7730 15TH AVE NW

Design Review Recommendation

July 18, 2016

SDCI Project # 3021006

PRIORITIES AND BOARD RECOMMENDATIONS: PROJECT RESPONSE

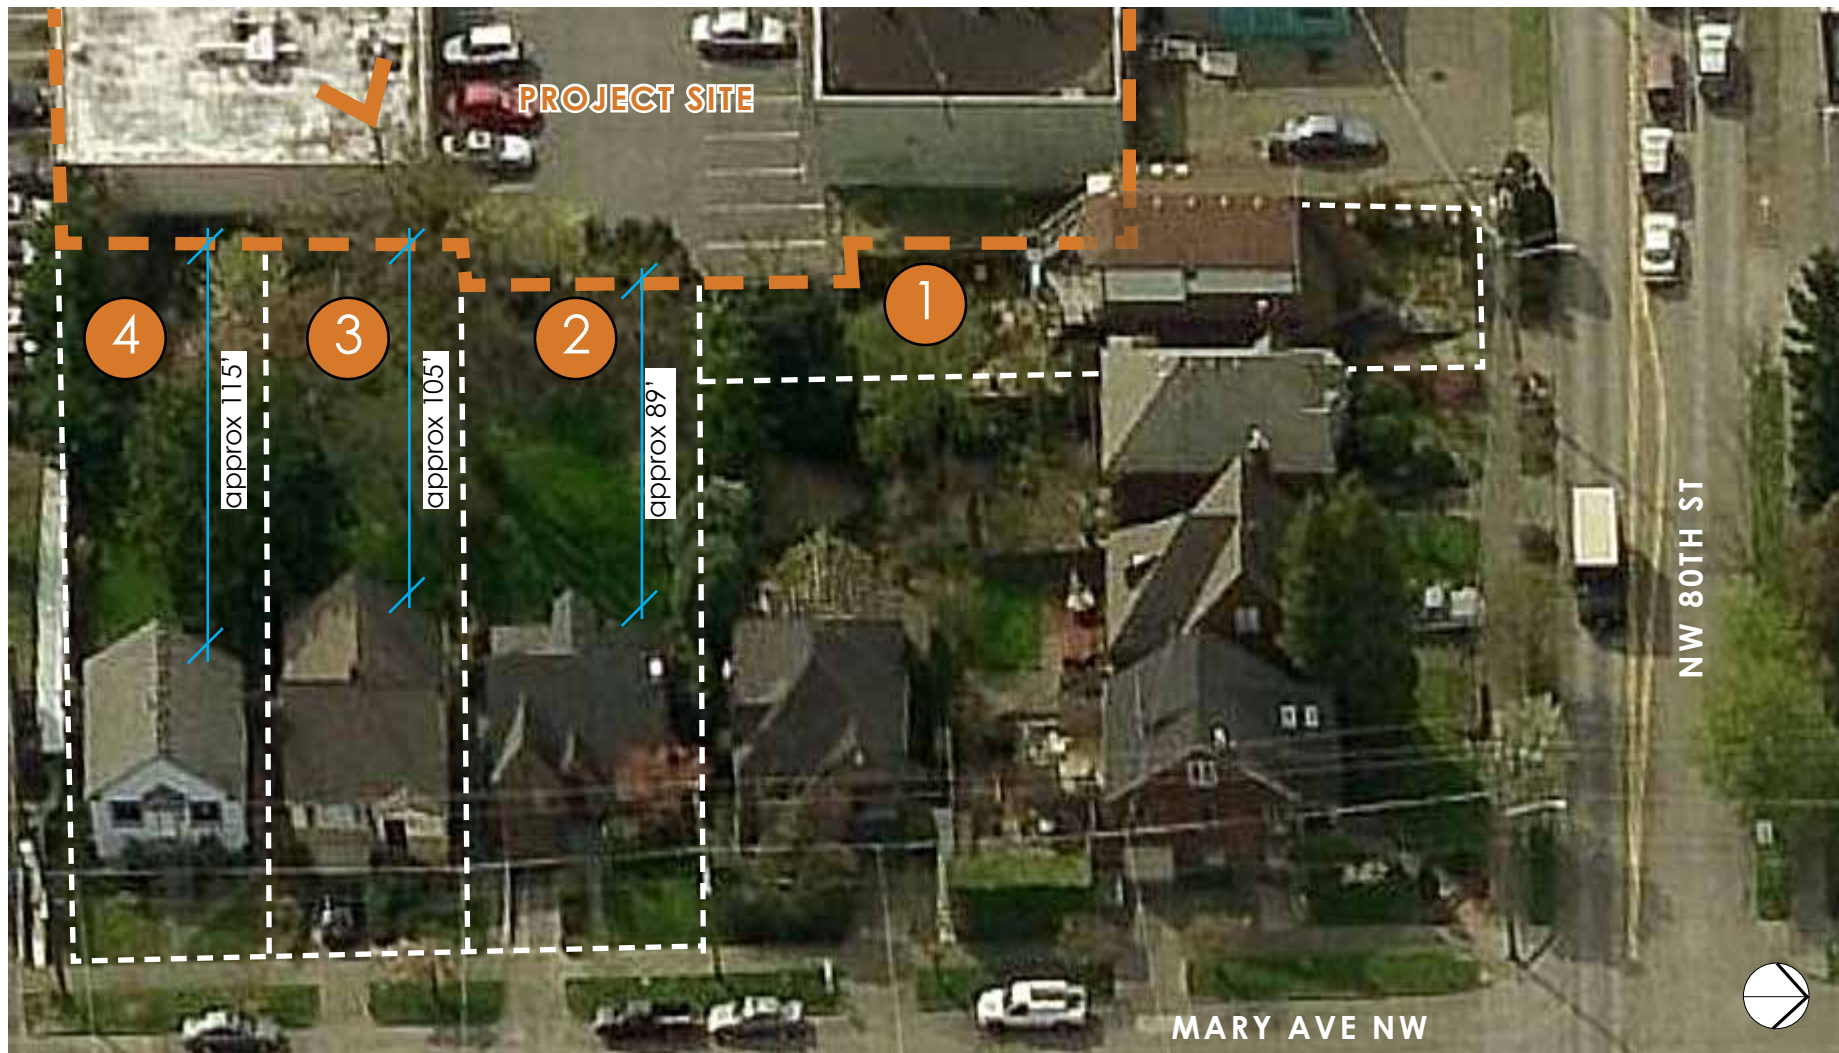
Board Direction: *"include additional detail/study of relationship with eastern neighbors (especially the NE neighbor); further develop and provide additional details on landscaping/screening along the eastern property edge. Fenestration and amenity space should be mindful of privacy of the neighboring property"*

Board Direction: *"encouraged the use of departures if they would result in a better relationship with eastern neighbors, and encouraged reduction of podium height, or appealing wall treatment, or landscaping along the eastern edge. Supported preferred design option, including the west upper floor setback, parking access away from 80th St intersection, and west ground level setback along 15th to enhance pedestrian experience."*

Board Direction: *"expressed concern about the north and south blank walls; provide additional detail on blank wall facade treatment. The east facade should blend into the background of single family yards and gardens"*

Board Direction: *"entries should be easily identifiable; provide additional information on residential entry and secondary architectural elements that reinforce the entry design. Minimize the impact of the driveway design on the pedestrian experience along 15th"*

PROJECT RESPONSE: east neighbor privacy relationship has been studied and more detail is now included. Areas of projecting decks have been removed and windows have been canted/rotated away from zones of highest privacy sensitivity. At-grade landscaping has been added along the NE property line to better provide a zoning transition. On-roof and on-podium landscaping has been positioned along the east edge to maximize privacy for site neighbors. Frequent modulation, a variety of siding materials, and enhanced texture at the garage wall along the east elevation provide a finer-grain scale transition to the east.

PROJECT RESPONSE: ground floor setback at east property line adjacent to NE single family neighbor has been increased and added ground floor landscaping provides screening of the garage wall. A departure has been added at the upper levels in order to cant/rotate windows to the south, improving privacy for the NE neighbor. The Board-preferred massing from EDG has been maintained/further developed

PROJECT RESPONSE: modulation has been added to the north/south facades to allow some windows in the center portion, and an artistic wall treatment is proposed for visual interest. Treatment of the east facade has been further developed and includes landscaping, modulation, texture and privacy at the base, and a variety of cladding materials above to reduce its sense of mass, blend into the background, and provide a better transition to the east

PROJECT RESPONSE: residential entry location has been shifted away from an existing street tree for higher visibility. Overhead canopy and building modulation along 15th Ave NW has been modified to better enhance and clarify entry locations. Driveway width is zoning minimum, located away from pedestrian entries, and interrupts streetscape planting strip as little as possible and garage door is semi-transparent to enhance safety and visibility of cars and pedestrians.

^ 3D diagram (from SE corner) of departure request

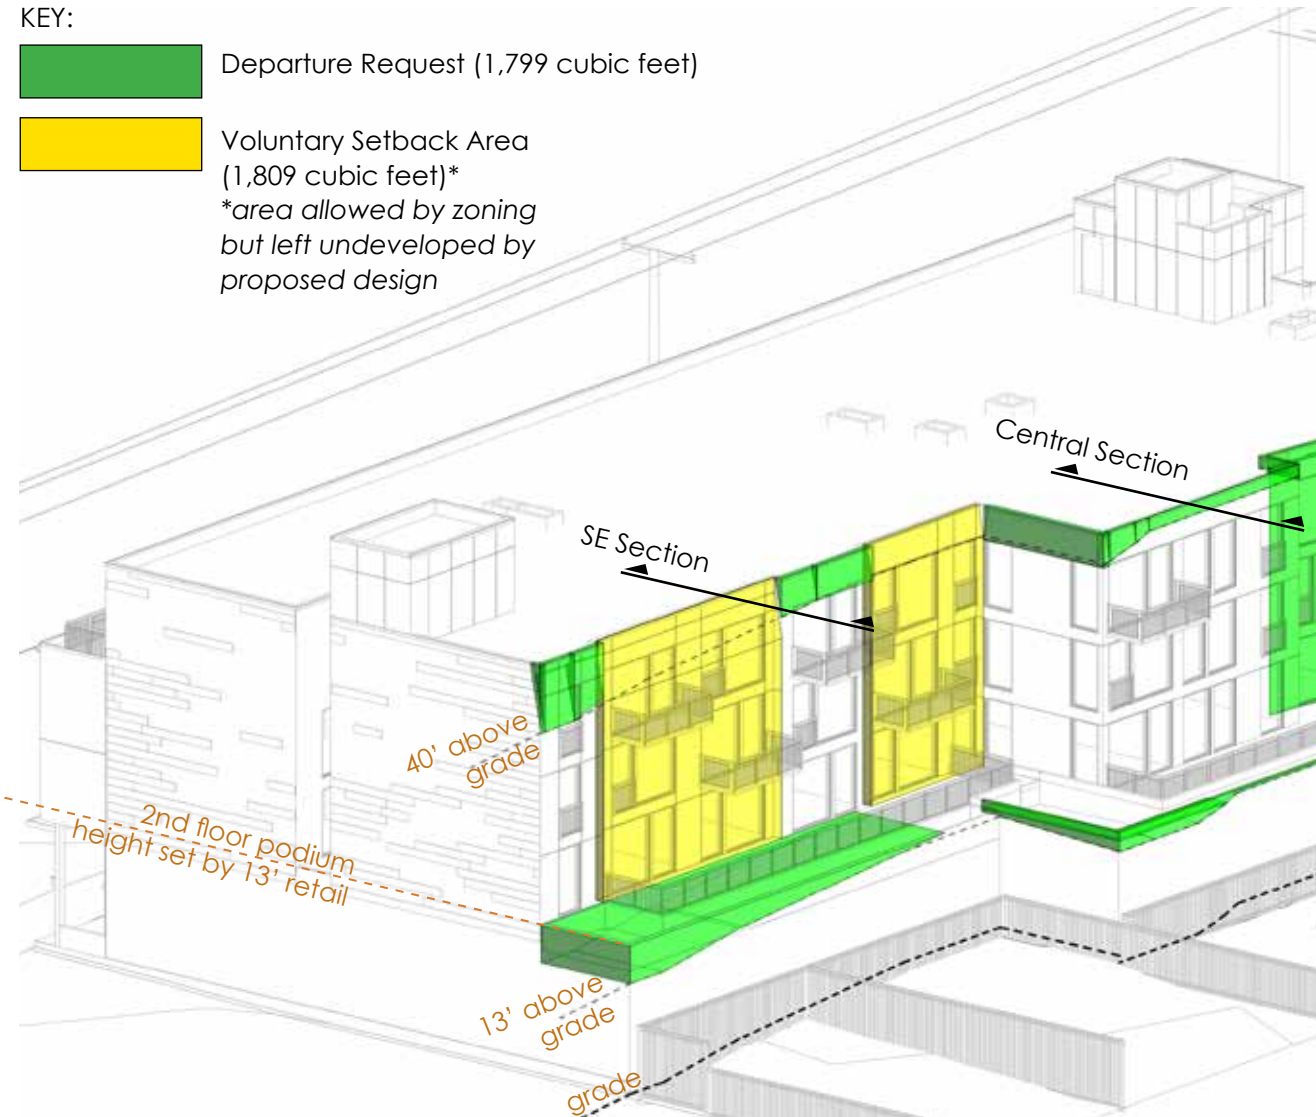
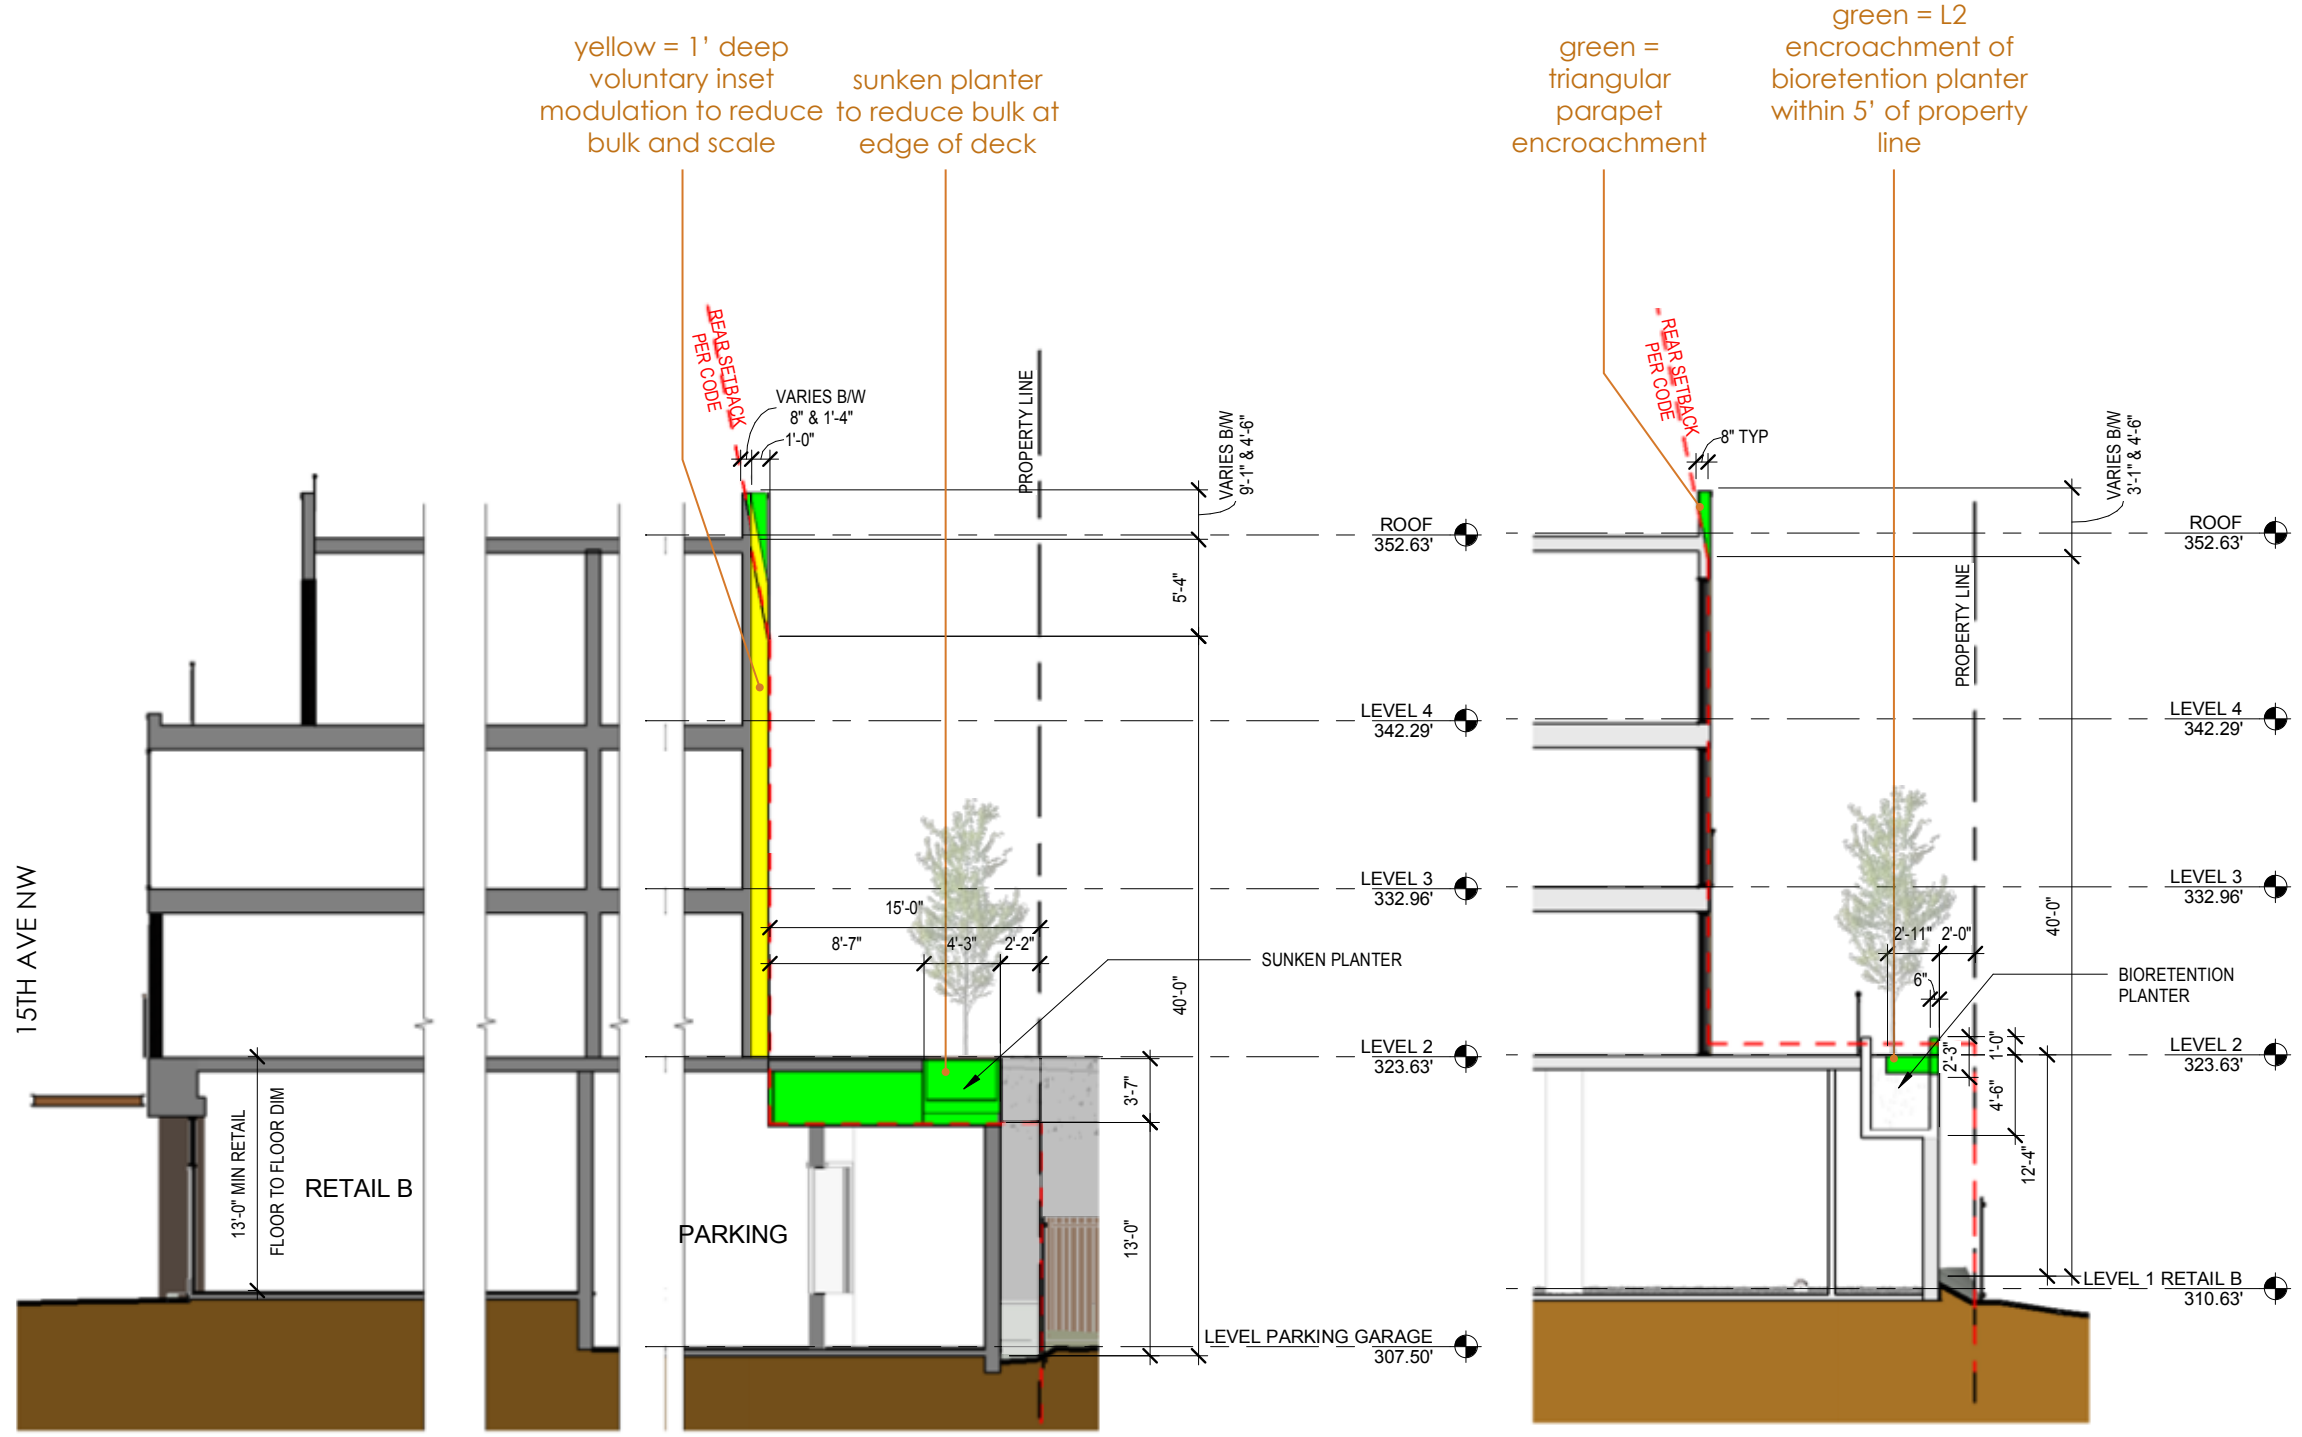
DEPARTURE	CODE REQUIREMENT	PROPOSED DESIGN	JUSTIFICATION
Side setback at east lot line bordering a residential zone - LEVEL 2 DECK	SMC 23.47A.014 B 3 a The code requires a 15' setback above 13' height abutting a residential zone	Due to existing topographic fluctuations and to allow viable ground floor retail along 15th Ave NW, several triangular areas along the top of the 2nd floor deck up to 3'-7" tall and 13' deep are in the setback area, resulting in a 2' setback instead of 15' near the top of the garage wall.	The elevation of the 2nd floor is determined by a 13' floor-to-floor height of Retail B along 15th Ave NW. The finished floor at the entry of Retail B matches the elevation of the existing sidewalk in order to maximize transparency and ADA Accessibility of the retail (GUIDELINES CS2.A.2: ARCHITECTURAL PRESENCE and CS2.B.2: CONNECTION TO THE STREET, and PL2.A.1: ACCESS FOR ALL). To minimize the scale of this departure request, a sunken planter buffer is provided along the southeastern edge of the Level 2 patios, which enhances privacy for site neighbors and reduces the visible height of the concrete garage wall by providing a contrasting cladding material. A code-compliant design would require retail spaces with finished floors well below sidewalk level.

Side setback at east lot line bordering a residential zone - ROOF PARAPET	SMC 23.47A.014 B 3 b The code requires a 15' setback above 13' height + a 2:10 sloped setback at portions above 40' height	Due to existing topography fluctuations, several small triangular zones along the top of the roof parapet up to 9'-1" tall and 1'-4" deep are in the setback area. This results in a 15' setback at the top of the parapet instead of an up to 17' setback. To reduce bulk and scale, modulation areas with a greater setback than is required by code are also proposed.	The east facade has been modulated and some areas of voluntary increased setback are proposed to better provide a bulk transition to adjacent single family zoning (GUIDELINE CS2.D.3: ZONE TRANSITIONS). The modulation visually divides the east elevation, breaking down the apparent scale of the building to better fit the smaller scale of the eastern neighbors (GUIDELINE DC2.A.2: REDUCING PERCEIVED MASS). In order to ensure an overall well-proportioned and composed facade that has an appropriate amount of visual depth and interest--given the increased setback at the inset bays--the flanking bays maintain a vertical continuum along the height of the facade instead of sloping back along the setback line (GUIDELINES DC2.B.1: FACADE COMPOSITION and DC2.C.1: VISUAL DEPTH AND INTEREST). A code-compliant design would be a flat, unmodulated east facade with an inward slope at the top along the sloped setback line above 40' in height.
